NOTICE OF NON-PERFORMANCE

On November 18, 2025, Energy Safety conducted an inspection of PG&E's WMP initiatives in the vicinity of the city of Santa Ynez, California. The inspection report is enclosed herewith. Energy Safety found the following deficiencies:

INSPECTION REPORT

Exhibit A: Photo Log

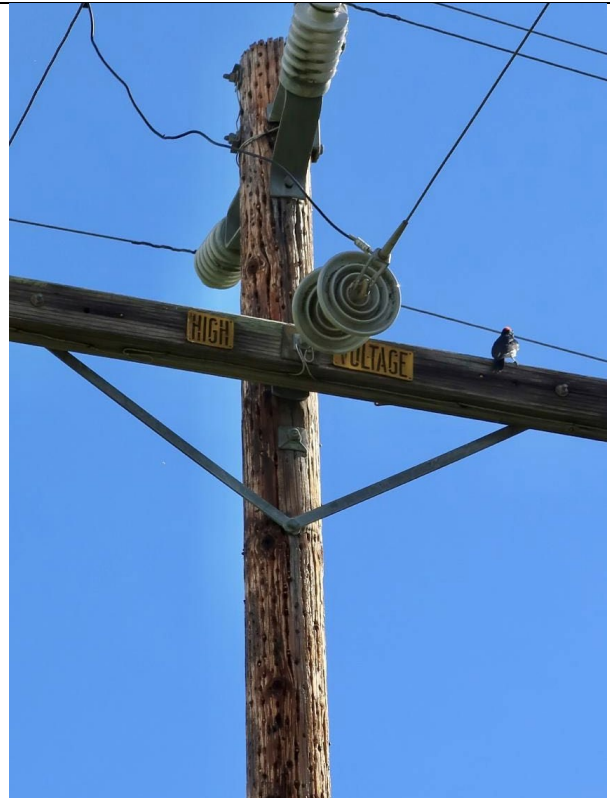
In the 2025 Q2 Quarterly Data Report submission, PG&E reported that work on WMP initiative 8.1.7.2 - Open Work Orders – Distribution Tags were completed at Pole ID 121160789, Grid Hardening ID 123958072 at 34.6739467793148, -120.08331151129. At this location, the inspector observed that the pole meets replacement criteria per TD-2305M-JA02 Rev. 14. The inspector noted that woodpecker (WP) damage, on a three-foot section, appeared to be greater than 50%. PG&E's original evaluation requested pole replacement, but when FSR was performed replacement was deemed unnecessary. The inspector's observation is documented in Deficiency 1 photographs, which are attachments to this report. Photo numbers IA1Img1, IA1Img2, IA1Img3, Item1IB1Img1-1, and Item1B1Img1-2, depict various views of WP damage and PG&E's inspection guidance of WP damage.

1. Field Safety Reassessment (FSR) was completed. Results of reassessment determined WP damage non-compelling, scheduled replacement was deemed unnecessary.
2. Inspector observed WP holes covering greater than 50% of the pole surface in a three-foot section at this location.
3. WP holes covering greater than 50% of the pole surface in a three-foot section warrants pole replacement per PG&E document TD-2305M-JA02 Rev 14.
4. Current WP activity observed at this location.

Deficiency 1. Energy Safety observed that in implementing 2025 WMP initiative 8.1.7.2 - Open Work Orders – Distribution Tags, PG&E failed to complete work on open work orders distribution tags on Pole ID 121160789, Grid Hardening ID 123958072 at coordinates 34.6739467793148, -120.08331151129. Energy Safety considers this non-performance to be in the Minor risk category. PG&E must complete a corrective action for this deficiency by 12 months from date of this notice.¹
